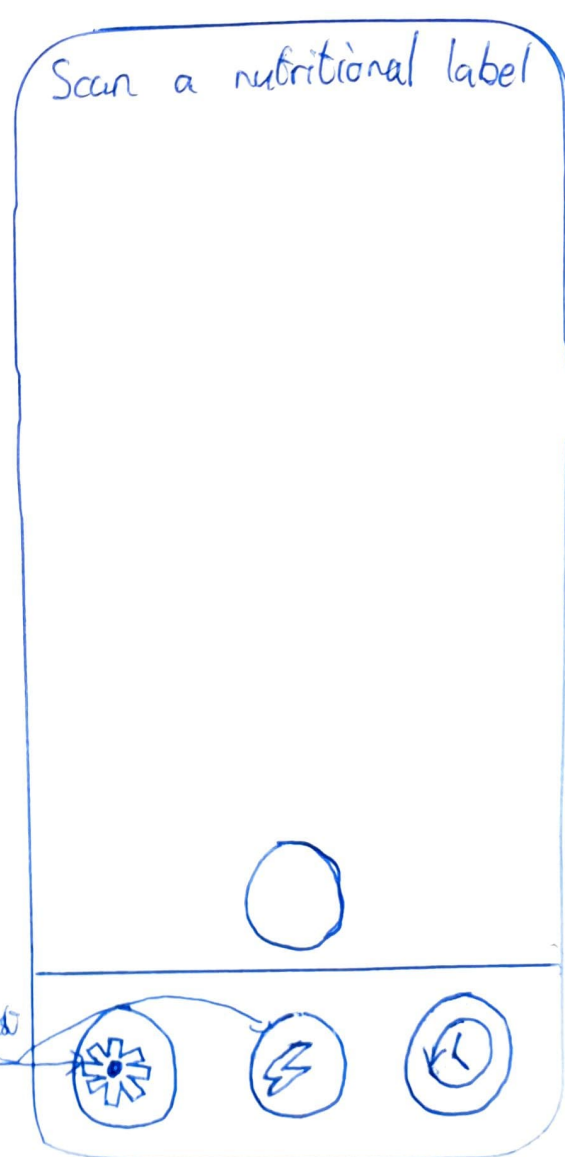
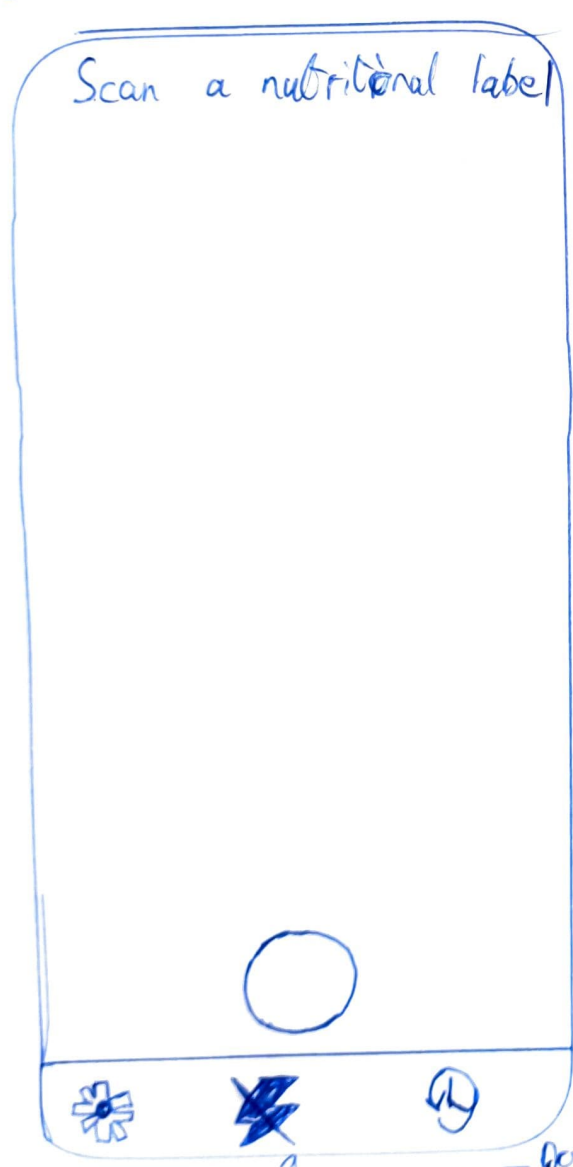
Should it stay here or move to the right for "breathing space"?

High-contrast buttons

Does flash belong here?  
Not a transition to a new screen.

- Is the overlaying frame necessary? Google Translate doesn't have a frame when scanning text. Bixby vision does it depending on content & dynamically.
- Tapping the screen should focus the camera, similar to other apps.
- Getting rid of labels allows for more of the screen to be used for pointing at the label
